Subject: GE Responses to the Resolution of Issues Related to ABWR DSER
Chapters 1,2,3,5,6,9,10,12,13,14 & 15 (SECY-91-355)

RESPONSE TO OUTSTANDING ISSUES (2) THROUGH (13)

SUMMARY RESPONSE TO OUTSTANDING AND CONFIRMATORY ISSUES OF
ABWR DSER CHAPTERS 1, 2, 3, 5, 6, 8, 10, 12, 13, 14 and 15
SECY-91-355

Figure 9.5-7 STANDBY DIE

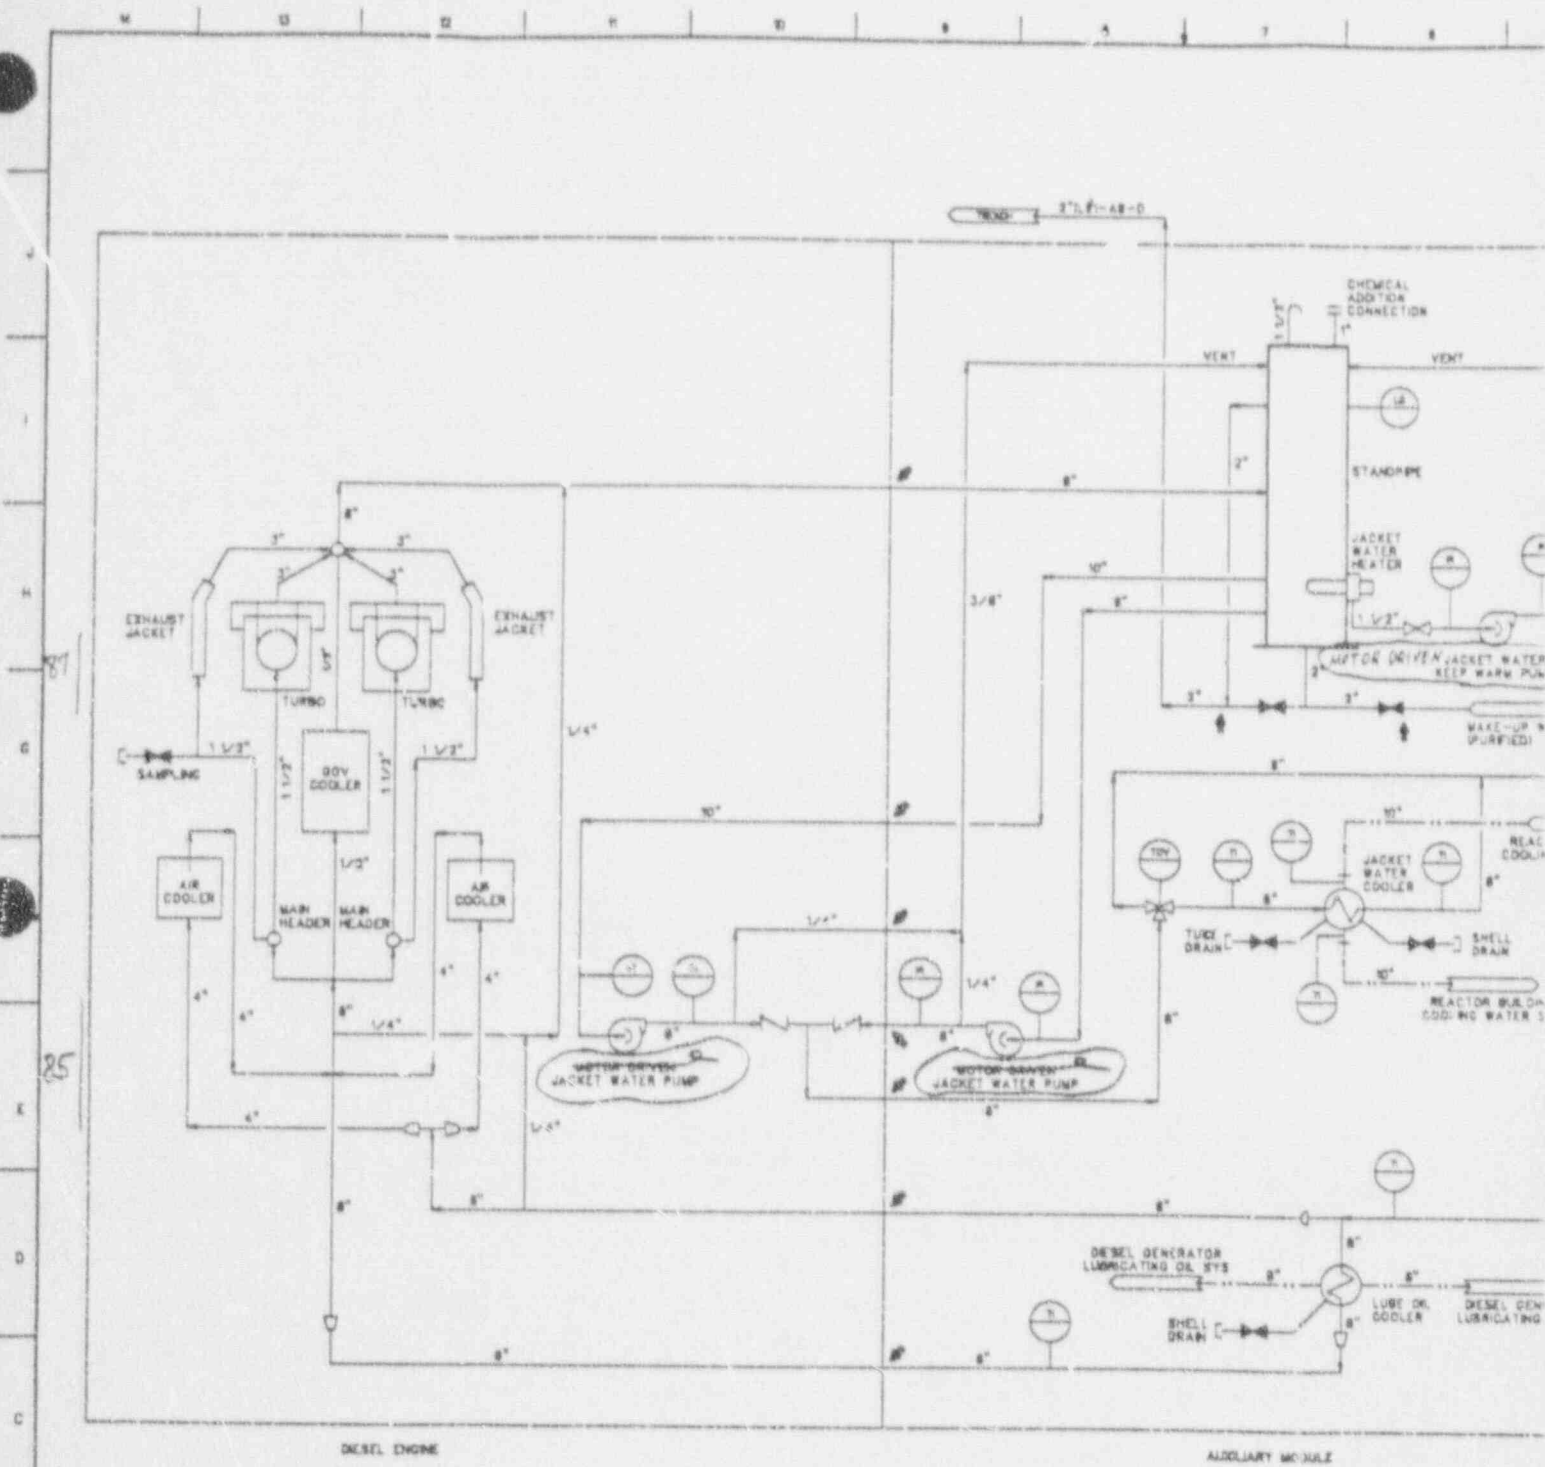
- 85 Discrepancies in SSAR regarding jacket circulating water pump (9.5.5) Subsection 9.5.5.2 (page 9.5-5) has been modified and the words "motor driven" have been deleted from both jacket water pumps on Figure 9.5-7 (page 9.5-19 attached). The interface requirement is correct in that the type of jacket water pump is dependent on the specific diesel manufacturer. (Page 9.5-5 is proprietary and is provided under separate cover).

- Also, the words "MOTOR-DRIVEN" were added the keep-warm pump symbol on Figure 9.5-7 (page 9.5-16 attached)
- Also, the cold start time (consistent with Chapter 8 DSER resolution) has been changed from 13 to 20 seconds (page 9.5-5.1) This page is proprietary and is provided under separate cover).

Figure 9.5-9 STANDBY DIESEL GENERATOR LUBRICATING OIL SYSTEM

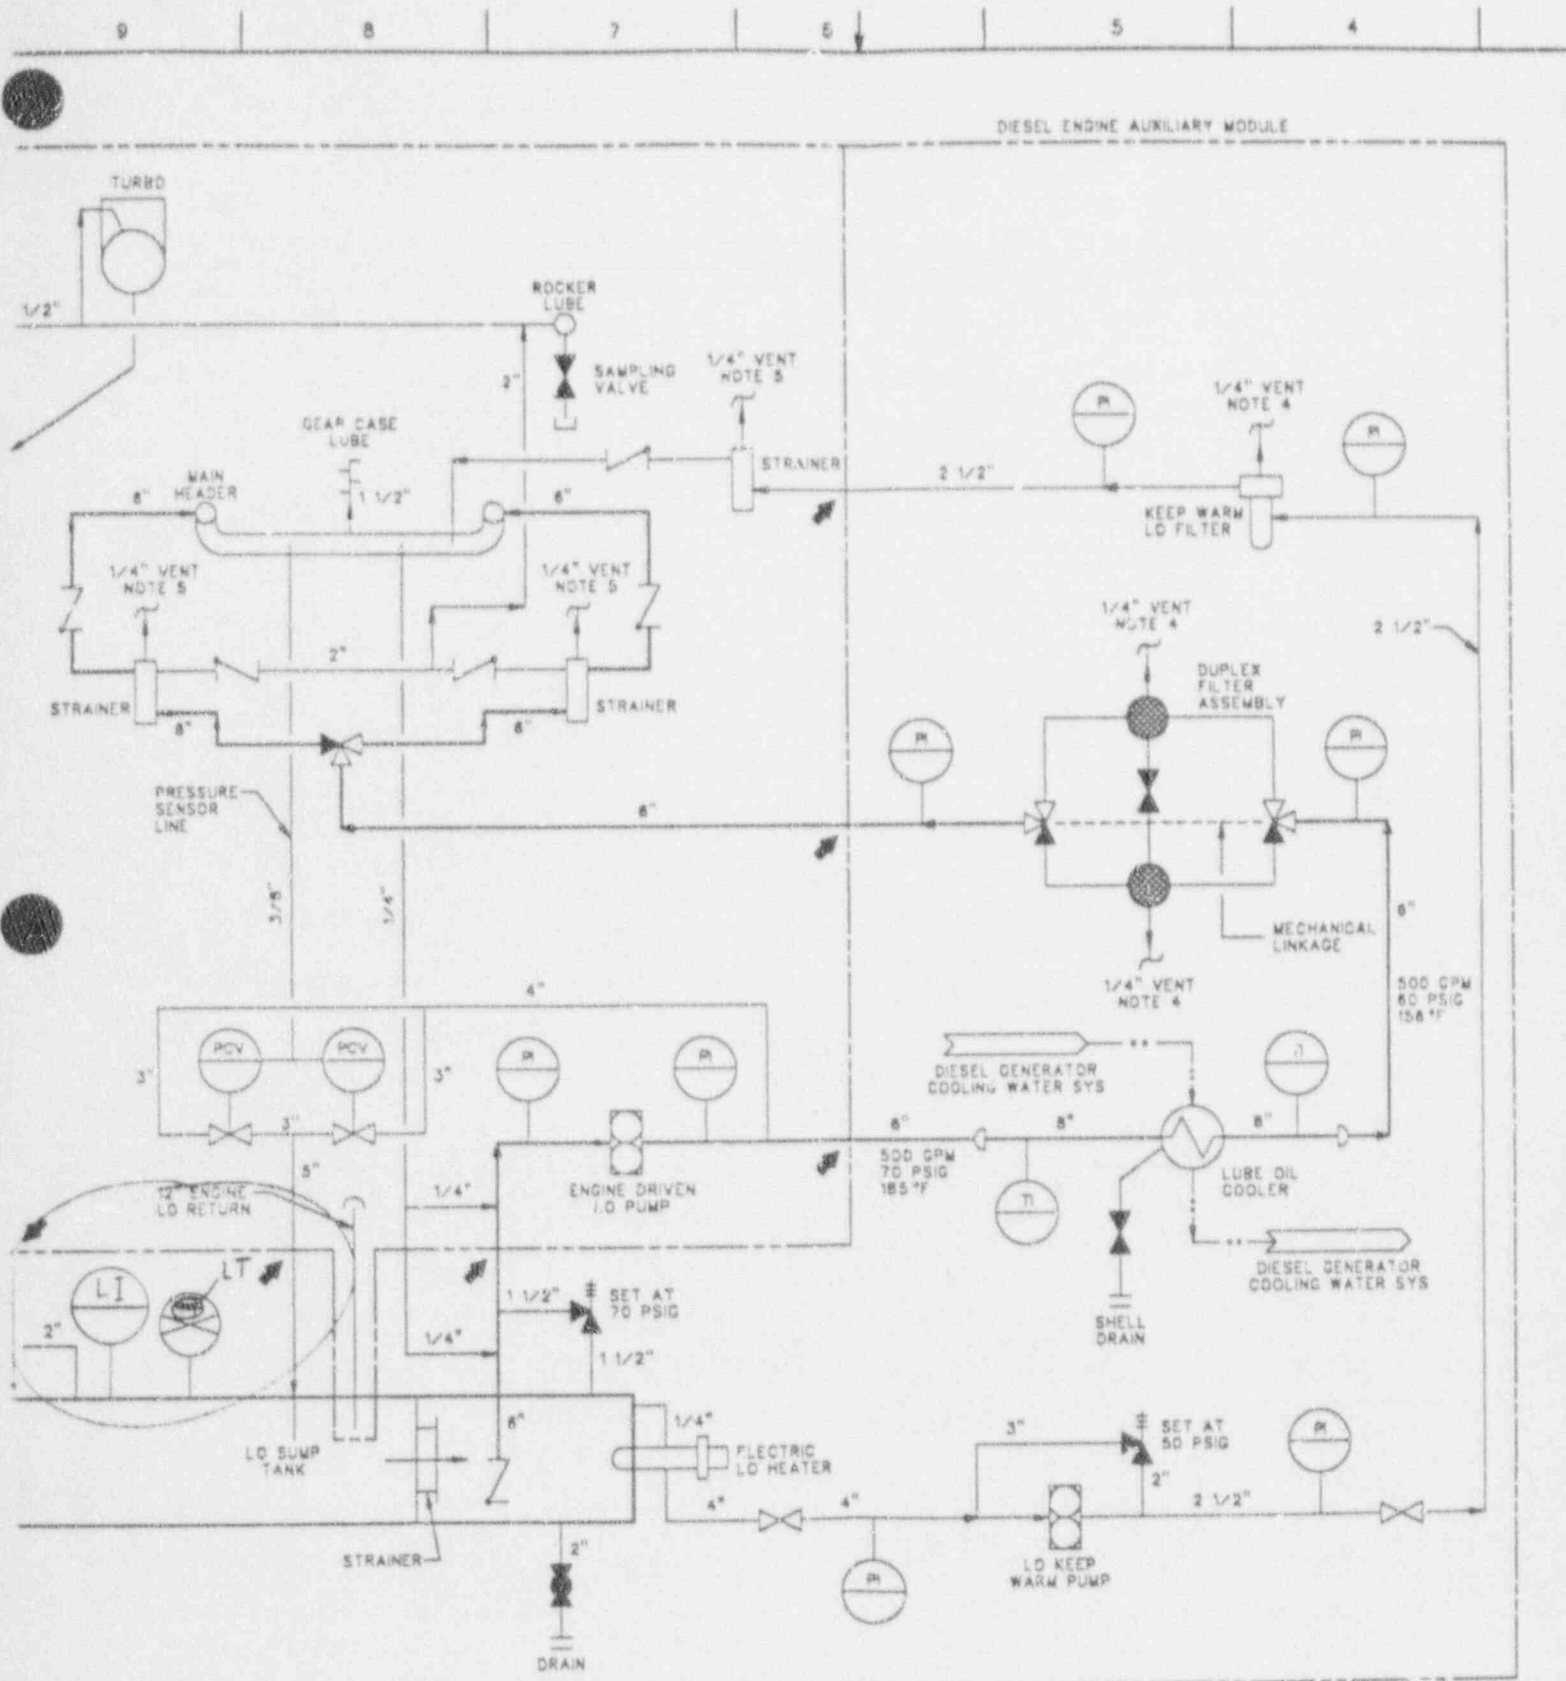
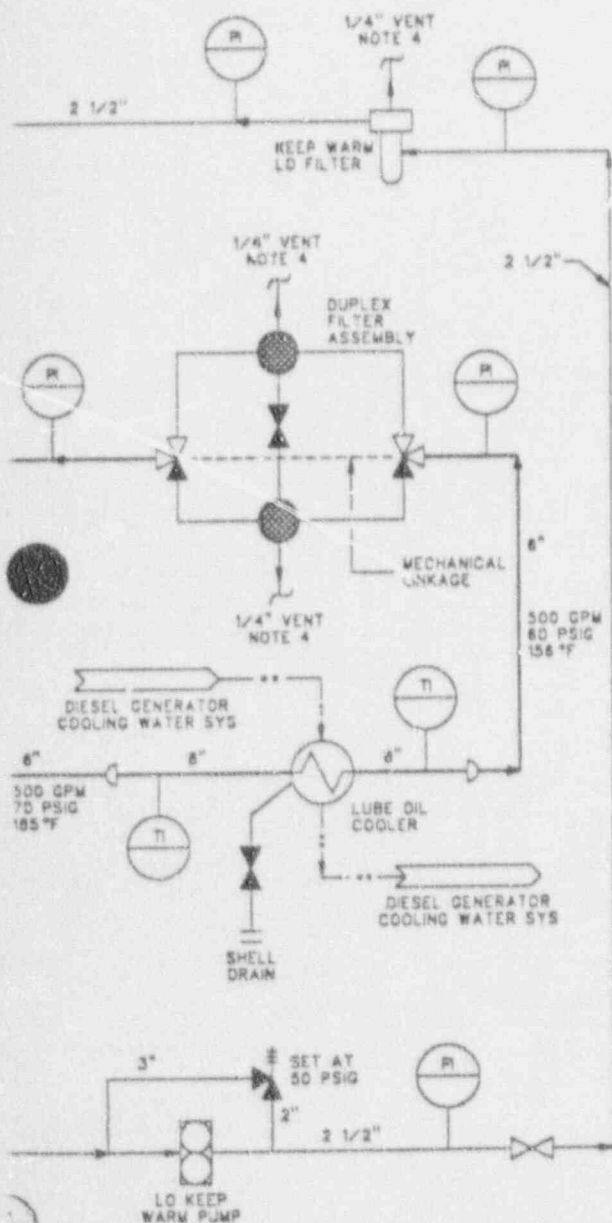
- 91 Omission of DG lubrication system level indication (9.5.7) The flow transmitter (FT) shown on the lube oil sump tank on Figure 9.5-9 (page 9.5-1 attached) is an error and corrected to "LT". Also, a locally mounted level indicator (LI) has been added to this figure.

- The response to Question 430.234 on page 20.3-369 was modified accordingly. (This page is proprietary and is provided under separate cover).
- 93 Classification of components in the DG lubrication system (9.5.7) Note 2 of Figure 9.5-9 (page 9.5-21 attached) has been expanded to identify the requirements of ANSI B31.1. Also, Item 4 of the Response to Question 430.271 (page 20.3-357) has been appropriately modified. (Page 20.3-357 is proprietary and is provided under separate cover).
